# Access Compliance Report

## Public Rights-of-Way

Intersection ID: 10027726	Main Street: GRIFFITH_RD	Cross Street: N/A	Location:	N
ADA ID: AA28BC3D6E97	Ramp Type: PerpDiag	Initial Pass/Fail: Fail	Overall Compliance: No	Severity Score: 22.5

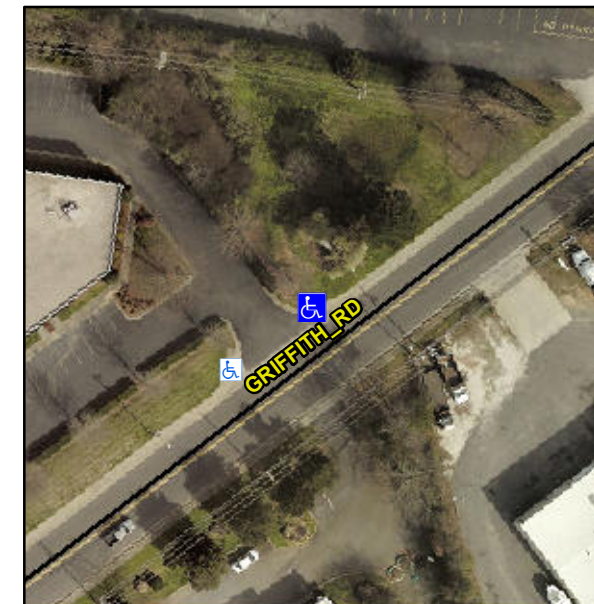
**R304.5.1, R304.2.2, R304.5.3**

Compliance	Description	Data	Compliance	Description	Data
N/A	Ramp Length (in)	60.0	No	Ramp Slope (%)	10.7
No	Ramp Width (in)	47.5	No	Ramp XSlope (%)	2.4
N/A	Flare Type LT	N/A	N/A	Flare Type RT	N/A
N/A	Flare Slope LT (%)	N/A	N/A	Flare Slope RT (%)	N/A
N/A	Flare Traversable LT?	N/A	N/A	Flare Traversable RT?	N/A
N/A	Landing Length (in)	N/A	N/A	DWS Provided?	N/A
N/A	Landing Width (in)	N/A	N/A	DWS Contrast?	N/A
N/A	Landing Slope (%)	N/A	N/A	DWS Length (in)	N/A
N/A	Landing X Slope (%)	N/A	N/A	DWS Full Width?	N/A
N/A	Landing Curb? (Y/N)	N/A	N/A	DWS Offset (in)	N/A
N/A	Shared Landing?	N/A			
N/A	Gutter Ponding?	N/A	N/A	Gutter Slope (%)	N/A
N/A	Gutter Lip Ht (in)	N/A	N/A	Gutter X Slope (%)	N/A
N/A	Painted X Walk1?	No	N/A	Painted X Walk2?	No
	X Walk 1 Direction	To SW		X Walk 2 Direction	To SE
N/A	X Walk 1 Width (in)	N/A	N/A	X Walk 2 Width (in)	N/A
	X Walk 1 Slope (%)	3.7		X Walk 2 Slope (%)	2.1
	X Walk 1 X Slope (%)	0.7		X Walk 2 X Slope (%)	3.1

**Remove & Replace Curb Ramp With Two New Directional Ramps or Equivalent.**
